## XC2200L Derivatives

16/32-Bit Single-Chip Microcontroller  
with 32-Bit Performance  
XC2000 Family / Econo Line

Errata Sheet

V1.3 2013-09

**Figure 1 Critical application reset sequence**

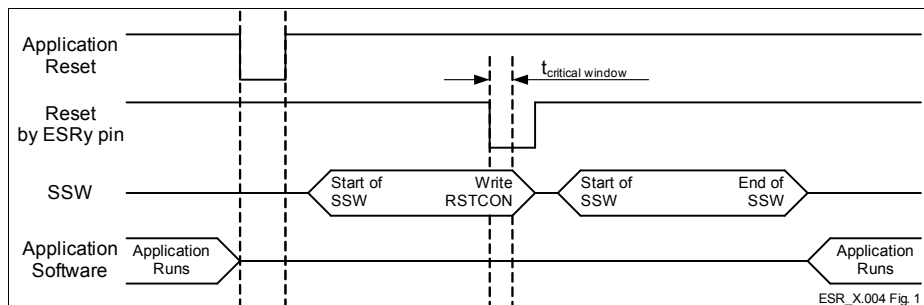
### **ESR\_X.004 Wrong Value of SCU\_RSTCONx Registers after ESRy Application Reset**

SCU\_RSTCONx registers are reset only by Power-On, but they may be wrongly affected after a second application reset requested by an ESRy pin. This may lead to the SCU\_RSTCONx register values being set to zero, which could unexpectedly disable reset sources within the user application. The conditions which lead to this behavior are:

1. First, an application reset by SW (software), CPU (Central Processing Unit), MP (Memory), WDT (Watchdog Timer) or ESRy (External Service Request y) occurs.
2. Following this, an application reset on an ESRy pin occurs.
3. If the above mentioned ESRy reset occurs during a critical time window of the SSW (startup software), then it's possible that the application will operate with the wrong SCU\_RSTCONx register value. The critical time window occurs when the SSW is writing the SCU\_RSTCONx registers, and at the same time, the ESRy reset request is processed by the reset circuitry. The width of this critical window  $f_{\text{critical window}}$  is less than 13 cycles.

- Initialize `SCU_RSTCONx` registers by user software after any reset, or
- assure that a second application reset request with an ESR pin does not occur during the critical time window.

**Figure 2 Alert Interrupt Behavior in case of Bus-Off**

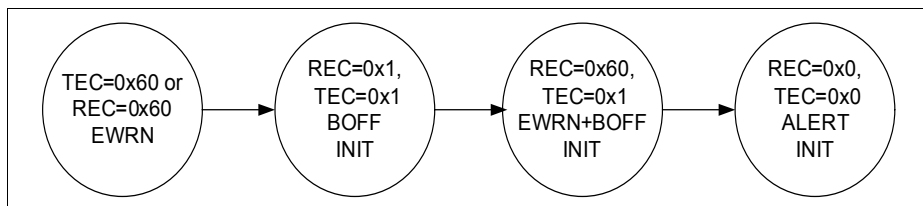
**MultiCAN\_AI.H007 Alert Interrupt Behavior in case of Bus-Off**

The MultiCAN module shows the following behavior in case of a bus-off status:

When the threshold for error warning (EWRN) is reached (default value of Error Warning Level EWRN = 0x60), then the EWRN interrupt is issued. The bus-off (BOFF) status is reached if TEC > 255 according to CAN specification, changing the MultiCAN module with REC and TEC to the same value 0x1, setting the INIT bit to 1<sub>B</sub>, and issuing the BOFF interrupt. The bus-off recovery phase starts automatically. Every time an idle time is seen, REC is incremented. If REC = 0x60, a combined status EWRN+BOFF is reached. The corresponding interrupt can also be seen as a pre-warning interrupt, that the bus-off recovery phase will be finished soon. When the bus-off recovery phase has finished (128 times idle time have been seen on the bus), EWRN and BOFF are cleared, the ALERT interrupt bit is set and the INIT bit is still set.
